C1980007, West Elk Mine, TR-151, Initial Adequacy Review

Re: West Elk Mine (Permit No. C-1980-007)
Technical Revision No. 151, (TR-151)
Initial Adequacy Review

Figure 1: Screenshot of map from Exhibit 10G, overlain with currently approved version of Map 51 and proposed revised version of Map 51. Annotation added.

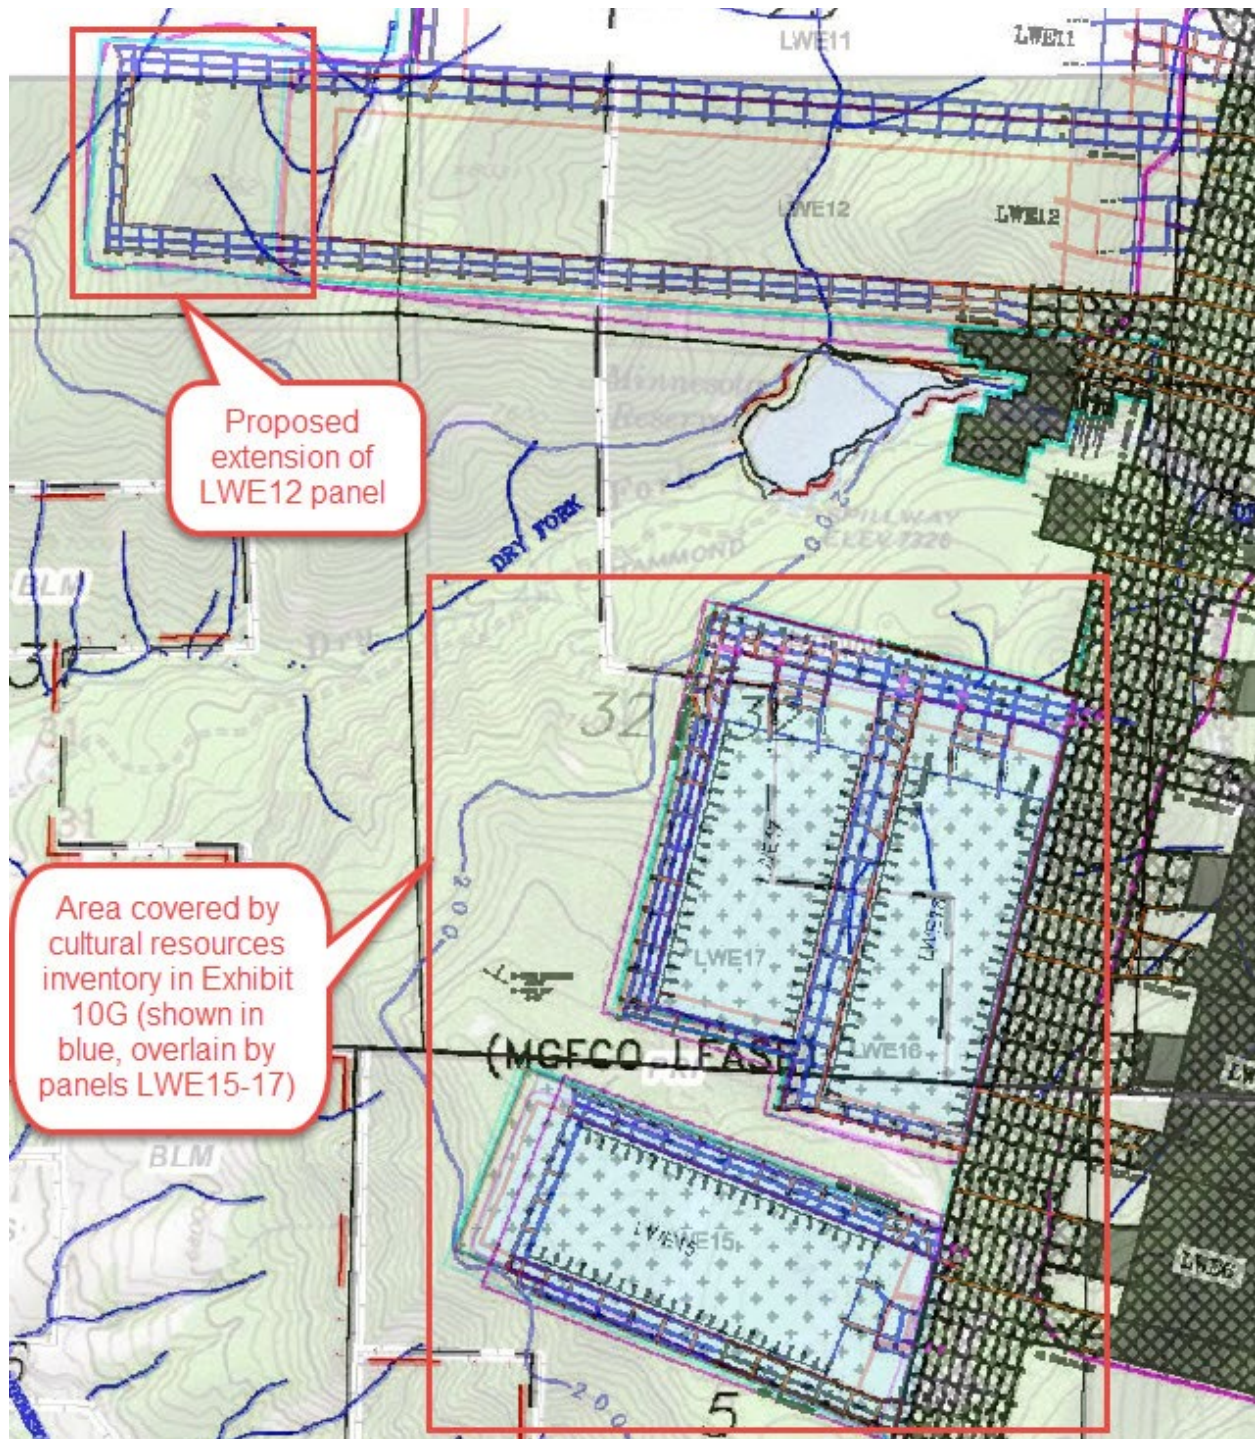
The text goes on to summarize the investigations that have taken place to support the above statement, and refers to the Map 7 series and the Exhibit 10 series. The field investigations documented in the Exhibit 10 series do not appear to cover the area proposed to be affected by proposed longwall panel LWE12. (See figure 1, below).

Please respond to the SHPO recommendation that a cultural resource inventory be completed for the area to be affected by the proposed extension of longwall panel LWE-12. If the area has already been inventoried please update section 2.04.4 of the PAP text to provide a reference.
